## Consolidated version of amendments and proposed modifications to CEVNI 5\*

\* As of 30 November 2020 , including amendments 1 to 3 (ECE/TRANS/SC.3/115/Rev.5/Amends.1–3), amendment 4 (ECE/TRANS/SC.3/2020/3) and the minutes of the thirty-third, thirty-fourth and thirty-fifth meetings of the CEVNI Expert Group (ECE/TRANS/SC.3/2020/4, CEVNI EG/2020/19 and CEVNI EG/2020/24).

49 bis	
Article 3.21: Additional marking for stationary vessels carrying out certain transport operations involving dangerous substances in accordance with Article 3.14, paragraph 1.		
	49 ter

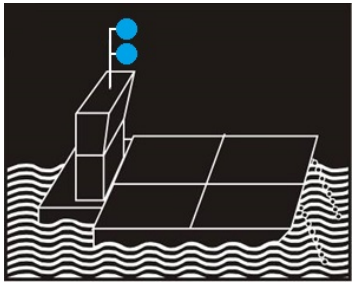
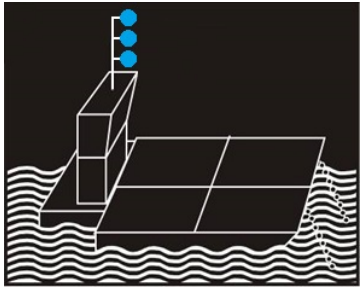
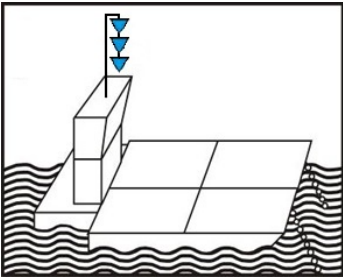
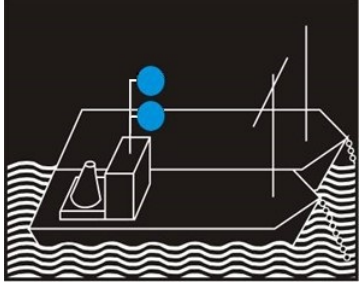
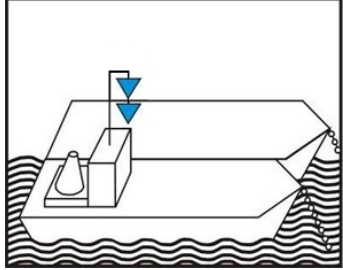
71	Add new sketches 49 bis – 49 quinquies	CEVNI EG/2020/24	
----	--	------------------	--

<p><b>49 quater</b></p>	
<p>Article 3.21: Additional marking for stationary vessels carrying out certain transport operations involving dangerous substances in accordance with Article 3.14, paragraph 2.</p>		
	<p><b>49 quinquies</b></p>	
<p>Article 3.21: Additional marking for stationary vessels carrying out certain transport operations involving dangerous substances in accordance with Article 3.14, paragraph 3.</p>
